# Submissions Report

SSD-72891212

57-61 Archer Street and 34 Albert Avenue,  
Chatswood

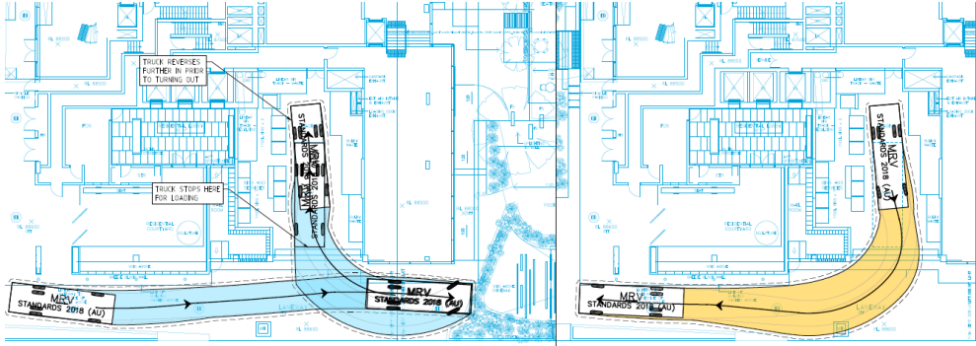
<p>vi. Tree retention and landscaping, including options to retain tree T18 and confirmation that the proposed tree planting around meet any easement / clearance requirements for any overhanging tree canopies.</p>	<p>As identified in the Aboricultural Impact Assessment (Appendix M of the EIS Package) submitted, tree T18 is required to be removed given that there would be over 33% encroachment into its tree protection zone (TPZ) by the basement construction, new stormwater pit, reduction in verge turf within the TPZ, proposed additional footpath/pavement and the substation.</p>

SUMMARY OF ISSUE RAISED	RESPONSE
	<p>Adequate tree planting and landscaping will be provided on the site to ensure a high level of visual amenity is provided on the ground plane.</p> <p>Ongoing consultation with Ausgrid will be undertaken to ensure the relevant easement and clearance requirements are met.</p>
<b>4. Landscape and public domain</b>	
<p>a) Clarify the rationale for the design of the southern through site link in relation to its public accessibility, layout and relationship / connection to the pocket park and Bertram Street.</p>	<p>As demonstrated in the Endorsed Bridging Design Excellence Strategy and Design Integrity Process Addendum (Endorsed BDES and DIP Addendum) (<i>Appendix AN of the EIS Package</i>) submitted, design refinements were made to the southern through site link in response to the recommendations by the DIP.</p> <p>Woods Bagot and Arcadia identified several design refinements to improve the visual and physical connectivity and landscape character of the through site link.</p> <p>The key design refinements made are summarised below:</p> <ol style="list-style-type: none"> <li>1. <i>Increase and extend landscaping into the through site link, working closely with the traffic consultant to ensure the on-grade space remaining will allow for the safe movement of service vehicles.</i></li> <li>2. <i>Provide additional deep soil along the Archer Street frontage.</i></li> <li>3. <i>Adjust the car park ramp as much as possible to widen the path above.</i></li> <li>4. <i>Increase the width of the link by adjusting the glazing line at the south-east corner of the ground floor commercial tenancy and hanging the planter box above the driveway.</i></li> <li>5. <i>Create an opportunity to shorten the path of travel via the park.</i></li> <li>6. <i>Minimise the height of the planter box to maximise visibility through the link.</i></li> <li>7. <i>Incorporate overhead lighting along the building face.</i></li> </ol> <p>Details of the design refinement are further discussed in the DIP Report.</p>
